Service Bulletin

21-027

September 30, 2022 Version 3

Safety Recall: 2019 Accord 2.0T Fuel Pump Motor

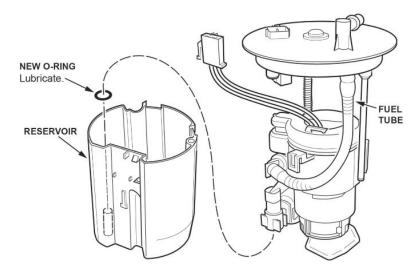
Under REPAIR PROCEDURE, step 30 was revised.

- 29. Install the new harness and make sure the connection is secure and the connectors are firmly locked into place.
- 30. Install the fuel pump into the fuel filter.
 - Be careful inserting the suction filter so it does not break. Use the palm of your hand to push in the entire surface
 of the suction filter into the module.
 - After installing the fuel pump to the strainer, move the lock part of the suction filter back and forth to make sure there is no rattling.
 - If installation with a single push is not accompanied by a click, remove all parts, reset the O-ring, then assemble again.
 - The O-ring cannot be reused once assembled. Replace it with a new one, then reassemble.
 - Take care that the flange does not hit other items because this may lead to a fuel leak.
